Relevant Information for Central Sydney Planning Committee

SUBJECT: Information Relevant To Item 13 – Post Exhibition – Planning Proposal – 47-
51 Riley Street, Woolloomooloo - Sydney Local Environmental Plan 2012 and
Sydney Development Control Plan 2012 Amendment

Figure 7: Riley Street elevation in context of surrounding development - recommended amendments to draft planning controls following public exhibition

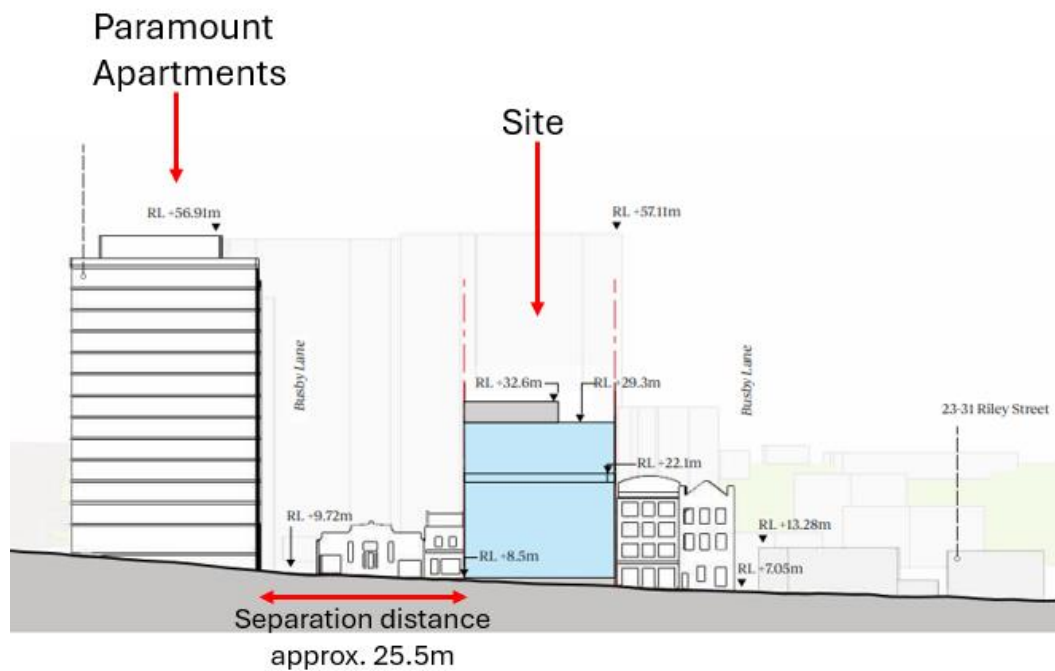
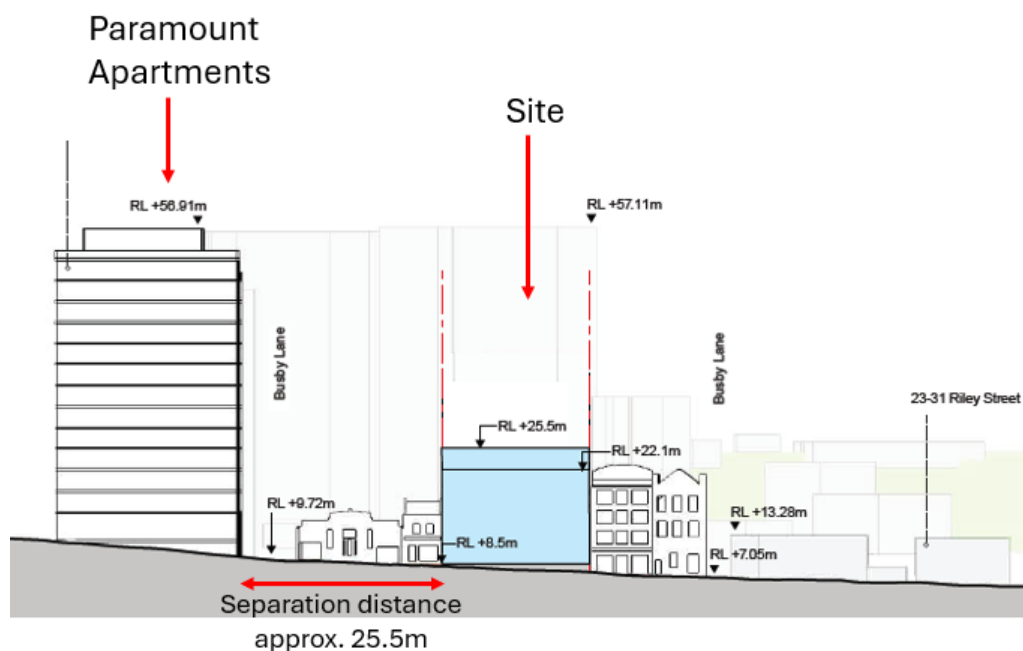
At the meeting of Council's Transport, Heritage and Planning Committee on 16 June 2025, reference was made to the images at Figures 6 and 7 in the subject report (reproduced below with dimensions and notes added). AHD RL is measured above sea level datum where as LEP height is typically above the footpath. The images show:

- the separation distance between the Paramount Apartments (60-70 William Street, Woolloomooloo) and the subject site is approximately 25.5 metres,
- the proposed maximum building height is recommended to be reduced by 7.1m to RL 25.5m from the exhibited maximum height of RL 32.6m which means the max height above the footpath is 17.9m compared to the current control of 12m,

- it is recommended that there be no allowance above the RL25.5m maximum height control for a roof top lift overrun, building plant, pergola structure or communal open space, and
- the recommended reduction in height will result in a smaller building envelope, and therefore the Floor Space Ratio (FSR) control is recommended to be reduced from 3.8:1 to 3.2:1 to match.
